Mask Set Errata 1

MC68HC12DA128 Microcontroller Unit

- 0K76A

Figure 2. Representation of unreliable start-up mode with slow crystal

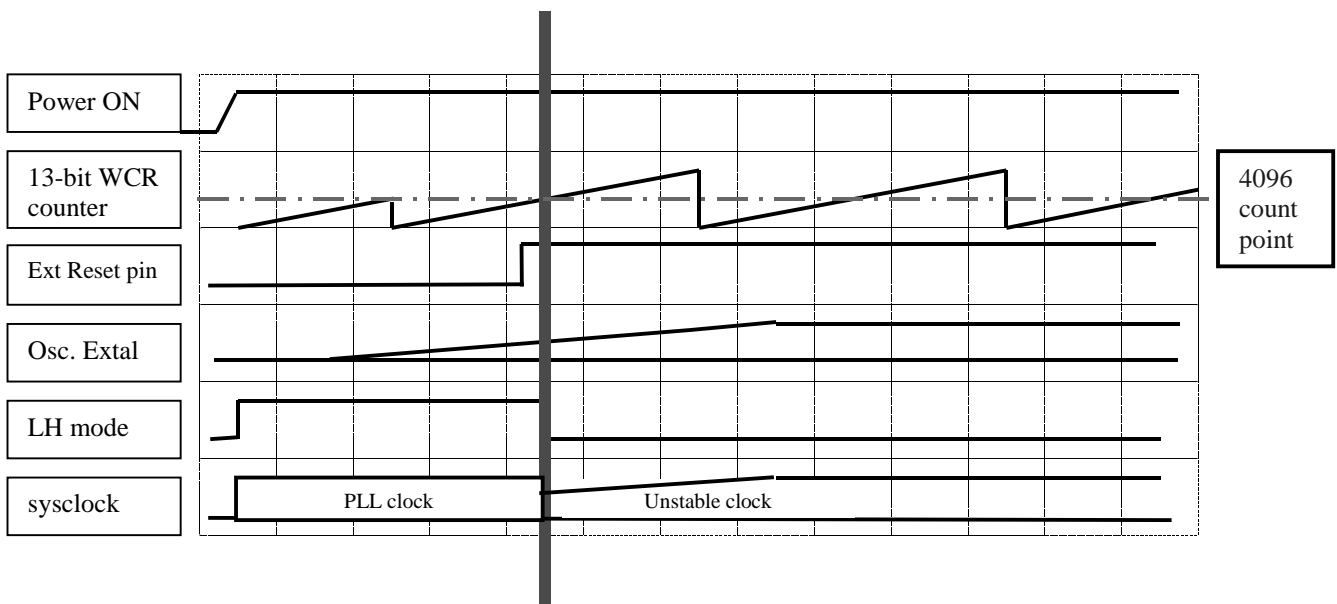
The HC12 mode of operation known as Limp-Home Mode (LHM) is enabled when the VDDPLL pin is at VDD and is entered if for any reason the external crystal ceases to oscillate. During this mode the CPU will be clocked from the free-running VCO clock of the PLL (at a nominal frequency of 1MHz). If LHM is enabled during the start-up phase (i.e. VDDPLL=5V, NOLHM bit=0) and the external RESET line is not held active until after the crystal frequency is stable then the device starts up in LHM since no crystal oscillations will be detected. This situation can arise with short reset periods and/or crystals that exhibit slow start-up characteristics.

For the first 4096 cycles i.e. during the internal reset period, Limp Home mode will be de-asserted if oscillator activity is detected by the clock monitor circuit -due to the asserted Reset signal there can be no CPU activity during the Reset phase. Following release of the external or internal POR RESET in LHM (which ever is later) the crystal oscillator is sampled by the clock monitor circuit after another 4096 VCO clock cycles and at intervals of 8192 clock cycles thereafter until the crystal is deemed to be operating. If the crystal oscillator is showing activity at the time it is checked then it will be deemed to be good, even though it may not have fully stabilized, and LHM will be de-asserted. This can cause the device to switch from LH mode to normal mode with the CPU clocked from an unstable signal from the crystal oscillator (see fig. 2) resulting in unpredictable function of the CPU.

Figure 3. Representation of preferred means of overcoming issue with Figure 2

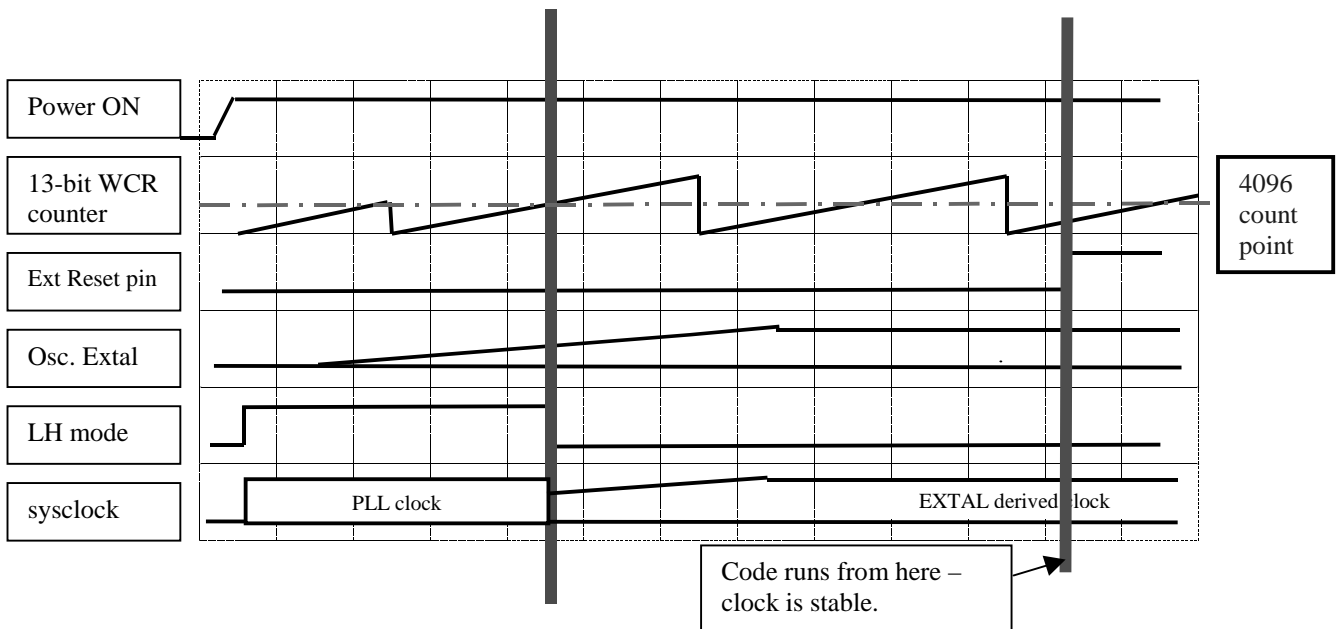
The Reset condition can be overcome by allowing the crystal oscillator circuit to stabilize before releasing the external RESET line (see fig. 3). Operation is similar to that shown in fig 2.

Lastly, an alternative and simpler approach is to just hold reset low for a substantial time (> 100 milliseconds) after Vdd has reached the operating voltage range.
